PROJECT: UAMS- CAMID

RE: 233423 - Dryer Fan

EQUIPMENT: Fantech Dryer Fan

TAGS: DF-1

DEDPV-705

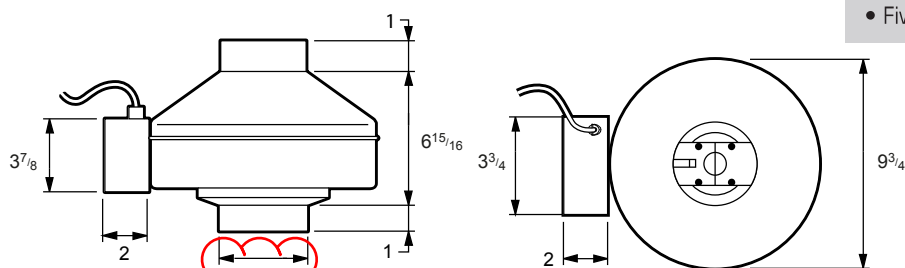
CDI: A/E please confirm ok.

CLARK & ENERSEN:
ACCEPTABLE, COORDINATE DUCT CONNECTION TO TRANSITION TO INSIDE OF 3 7/8" FAN CONNECTION TO PREVENT LINT BUILDUP.
